File No. LDA12-0354

RE: Tentative plan of subdivision to create 114 single detached residential lots, 36 semi-detached residential lots and 1 Environmental Reserve parcel, 1 Municipal Reserve Parcel and 2 Public Utility Lots from SE 8-52-23-4 and Lot 2, Plan 812 1577 located east of 11 Street NW and south of 36A Avenue NW; **MAPLE**

**I The Subdivision by Plan is APPROVED on May 30, 2013 subject to the following conditions:**

## SUBDIVISION CONDITIONS OF APPROVAL MAP

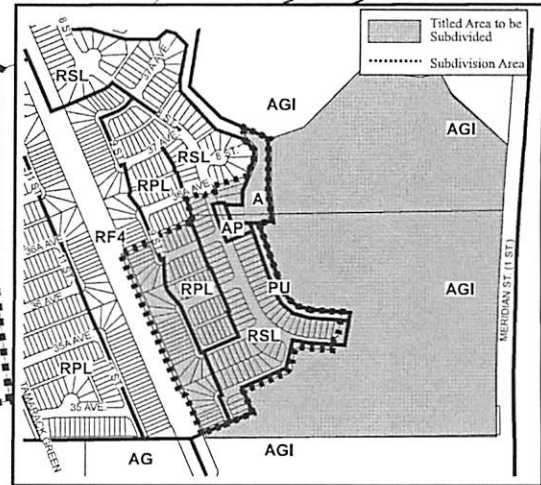
1. that the owner dedicate Environmental Reserve as a 0.80 ha parcel pursuant to Section 664 of the Municipal Government Act as shown on the "Conditions of Approval" map, Enclosure I;

2. that the owner dedicate Municipal Reserve as a 0.15 ha parcel pursuant to Section 666 of the Municipal Government Act as shown on the "Conditions of Approval" map, Enclosure I;

5. that the subdivision boundary be amended to include the dedication of Maple Road to an approved Concept Plan from the south boundary of SE-8-52-23-4 to the north boundary of Lot 2, Plan 812 1577 as shown on the "Conditions of Approval" map, Enclosure I;

7. that the owner register the walkways and the northerly PUL as road rights-of-way as shown on the "Conditions of Approval" map, Enclosure I;
8. that the lands to be gifted to CN along the western boundary of the subdivision, as shown on the "Conditions of Approval" map, Enclosure I, be done after the construction of the berm and fence; and

7. that the engineering drawings include a 12 m radius gravel surface temporary turnaround with bollards or mini-barriers to the satisfaction of Transportation Services, prior to CCC, as shown on the "Conditions of Approval" map, Enclosure I;

8. that the engineering drawings include upgrade to the existing temporary 4 m gravel emergency/temporary access to a paved 9 m rural roadway cross section including lighting to provide for a temporary secondary access to Meridian Street, as shown on the "Conditions of Approval" map, Enclosure I;;

9. that the engineering drawings include a grading plan for Maple Road;
10. that the owner construct a 1.5 m concrete sidewalk with bollards and lighting, to the satisfaction of Transportation Services, as shown on the "Conditions of Approval" map, Enclosure I;

11. that the owner construct 3 m asphalt shared use paths with a dividing yellow centerline and "Shared Use" signage with landscaping, as shown on the "Conditions of Approval" map, Enclosure I;

12. that the owner construct a combination berm and noise attenuation fence, to a minimum height of 4.5 m above the top of rail, within property lines along the east side of the CNR right-of-way, as shown on the "Conditions of Approval" map, Enclosure I;

13. that the owner construct a 1.8m noise attenuation fence on the lot adjacent to Maple Road as shown on the "Conditions of Approval" map, Enclosure I;

14. that the owner construct a 3 m sidewalk to connect the shared use paths as shown on the "Conditions of Approval" map, Enclosure I;
15. that the engineering drawings include a 250mm offsite water main to the satisfaction of EPCOR Water as shown on the "Conditions of Approval" map, Enclosure I;

16. that the owner construct all fences (wholly within private property lines excepting post and rail fencing on the MR parcel), to the satisfaction of Transportation Services and Sustainable Development in the locations as shown on the "Conditions of Approval" map, Enclosure I; and
17. that the owner is responsible for the design, landscaping and construction within the public utility lots, utility rights-of-way, road islands, boulevards, medians, walkways, and Reserve parcels, to the satisfaction of the Infrastructure Services, Transportation Services and Sustainable Development as shown on the "Conditions of Approval" map, Enclosure I.
